## ***Interactive comment on “The Interactions between Soil-Biosphere-Atmosphere (ISBA) land surface model Multi-Energy Balance (MEB) option in SURFEX – Part 2: Model evaluation for local scale forest sites” by Adrien Napoly et al.***

**Adrien Napoly et al.**

Interactive comment on Geosci. Model Dev. Discuss., doi:10.5194/gmd-2016-270, 2016.

Fig. 1.

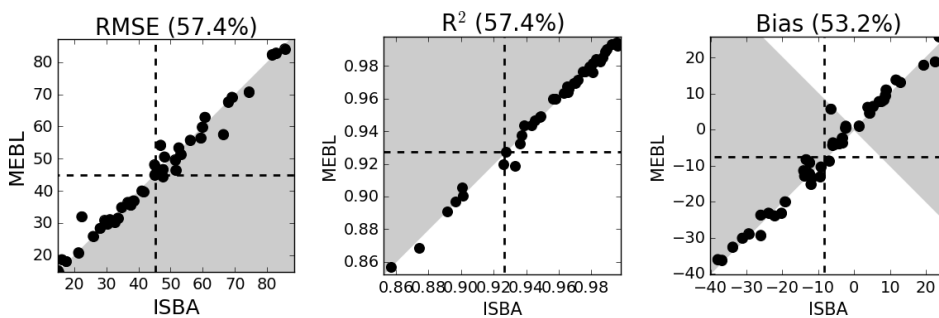
Comment : P 16. Can you also include a figure for Rnet comparison?

Answer : Please find attached the figure named fig2.png for an Rn comparison. However, we think that this figure does not add much since there are mostly minor differences between the two models. The main information in fig2.png is that the average over all sites is slightly biased and that RMSE is higher, compared to the three local sites (due to more uncertainties in albedo, LAI . . . ) : this is already explained in the text. We can add this figure, but since we feel it does not add alot of additional information and since the paper already includes a lot of figures, we can let this reviewer the editor decide.

**Fig. 2.**

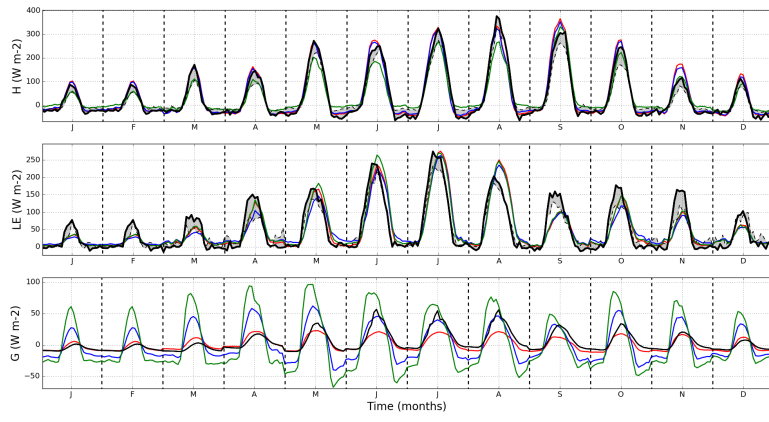
Comment : Section 5.3: In world wide assessment, is it possible to report also the results with MEB? It would be interesting for readers to see how including litter layer will affect the results.

Answer : We plot on fig5.png the results for RMSE calculations for H (left panel) and

LE (right panel). It shows that the litter option almost always performed better for both H and LE. We chose not to show this result mainly for 2 reasons: first, because the paper already includes many figures and we have tried to include those that are the most essential, and second, because the first part of the validation already showed the necessity of the litter representation so that the litter option can be considered for forest as the default version. That being said, if this reviewer think that it is necessary, we propose to add this figure (fig5.png) in the appendix. We propose to refer to it in the text (if it is added) by adding the text: “ As mentioned in Section 5.1, significant improvement is obtained with MEB compared to ISBA, and even more improvement with MEBL. An example of the improvement in H and LE between MEB and MEBL is shown in Appendix C Fig.16. But because of the consistently best behavior with MEBL verses ISBA compared to MEB, MEBL has become the default option for forests.”

**Fig. 3.**

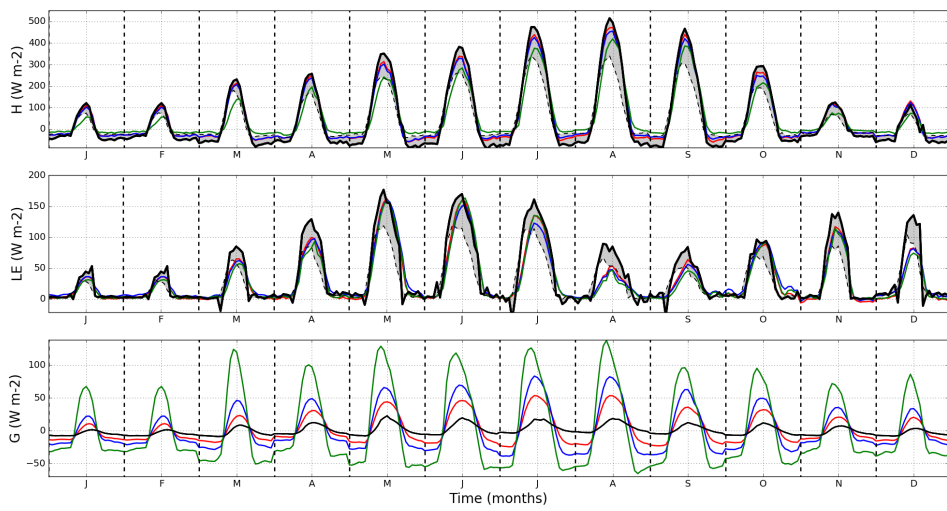
Comment : Figures 4b and 5b: Hard to see the lines. Can you possible change the scale of the yaxis ? also add the units in on Y-axis. Shaded are is not shown well in the figures.

Answer : We have plotted both turbulent flux components with the same scale so as the reader can easily understand that the energy from the G mostly goes into H. fig3.png and fig4.png shows figures 4 and 5 of the paper, respectively, with changes to the yaxis

scale. We think that the new figure could bias the reader in terms of the relative weigh of H and LE and that it doesn't add much information since the LE fluxes are quite similar between the models.
